Access Compliance Report Public Rights-of-Way (Pedestrian Signals)

Main Street: **VAN_BUREN_ST** Cross Street: **BOLSA_AVE** Location: **SW**

ADA ID: **SGRK210930111447** Signal Type: **One Push Button-Non APS** Overall Compliance: **No** Severity Scores: **BTN 1: 25** **BTN 2: N/A** **No BTN: N/A**

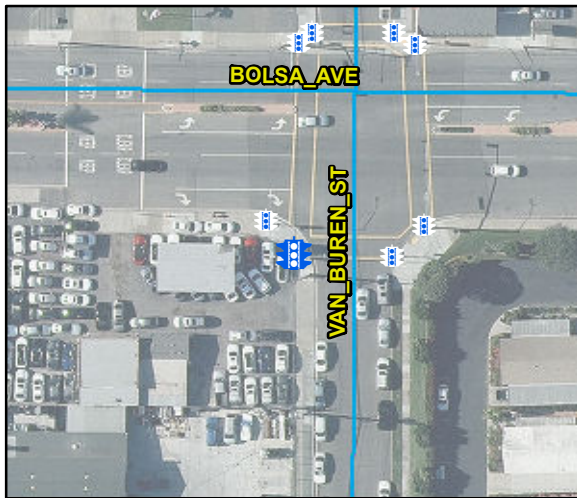
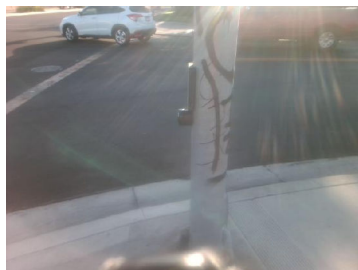
OC Std/PROW: **R404.2, R404.3**

Possible Solutions: Remove and Replace Clear Space.
